**GOVERNMENT OF THE DISTRICT OF COLUMBIA
DEPARTMENT OF TRANSPORTATION**

MEMORANDUM

SUBJECT: BZA Case No. 19689 – 1630 Crescent Place NW & 2300 16th Street NW (Meridian International Center)

Figure 2 – Preliminary Curbside Plan (Source: Memorandum from Applicant dated February 23, 2018)

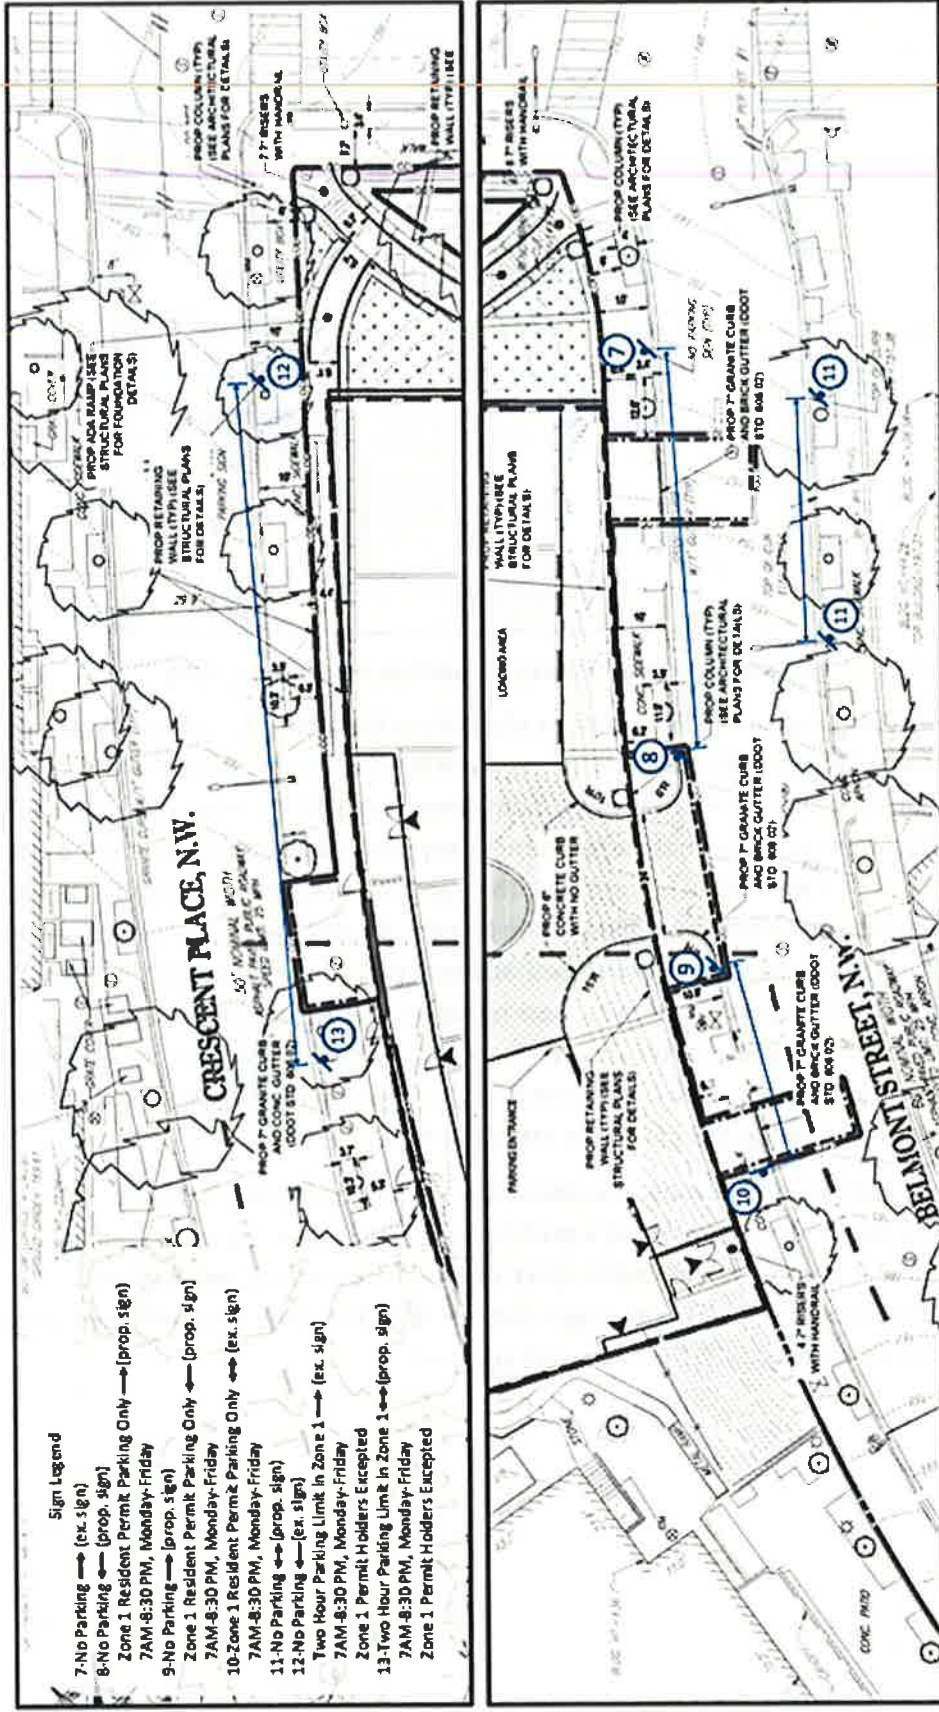
- Any voluntary turn restrictions for exiting site traffic should be placed on private property and should be managed and enforced by the Applicant;
- The Applicant has prepared a curbside parking plan (Figure 2) and should integrate any future proposed pavement marking changes, such as "Do Not Block the Box" striping, into one plan for DDOT's review and approval during the public space permitting process;

Relocating site access to the two-way portion of Belmont Street NW will require changes to existing parking restrictions. The Applicant has submitted a preliminary curbside plan (Figure 2), and has additionally indicated that it plans to submit public space permits for pavement markings to accommodate community requests. DDOT encourages the Applicant to submit a consolidated signage and marking application package for DDOT’s review and approval.
